**REMARKS/ARGUMENTS**

Appl. No. 10/735,323  
Amd. Dated December 8, 2005  
Reply to Office Action Dated July 26th, 2005

FIG. 2B  
(Prior Art)

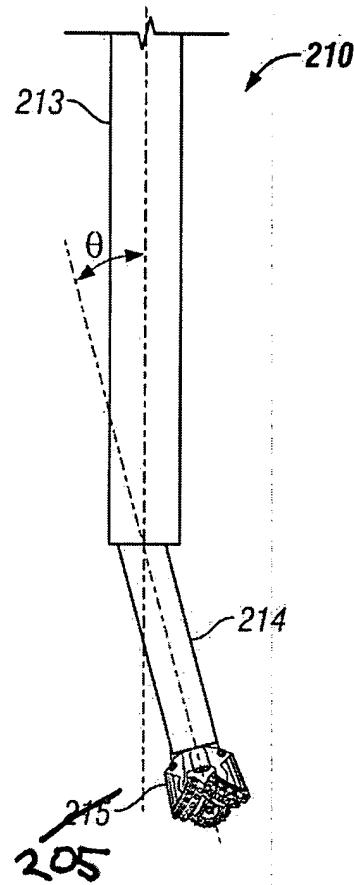
The Examiner objected to the drawings as failing to comply with 37 CFR 1.84(p)(5) because they include the following reference sign mentioned in the description: "215." Applicants have amended Figure 2B of the specification to include the reference number 205 rather than 215, 205 appears in the description. No new matter has been added by way of this amendment. Applicants respectfully submit that this amendment obviates the objection.

The attached sheet 3 of the drawings includes changes to Fig. 2B. This sheet, which includes Figs. 2A and 2B as well, replaces the original sheet 3 including Figs. 2A, 2B and 2C. In Fig. 2B, the reference numeral 215 has been replaced by 205. No new matter is added by this amendment.
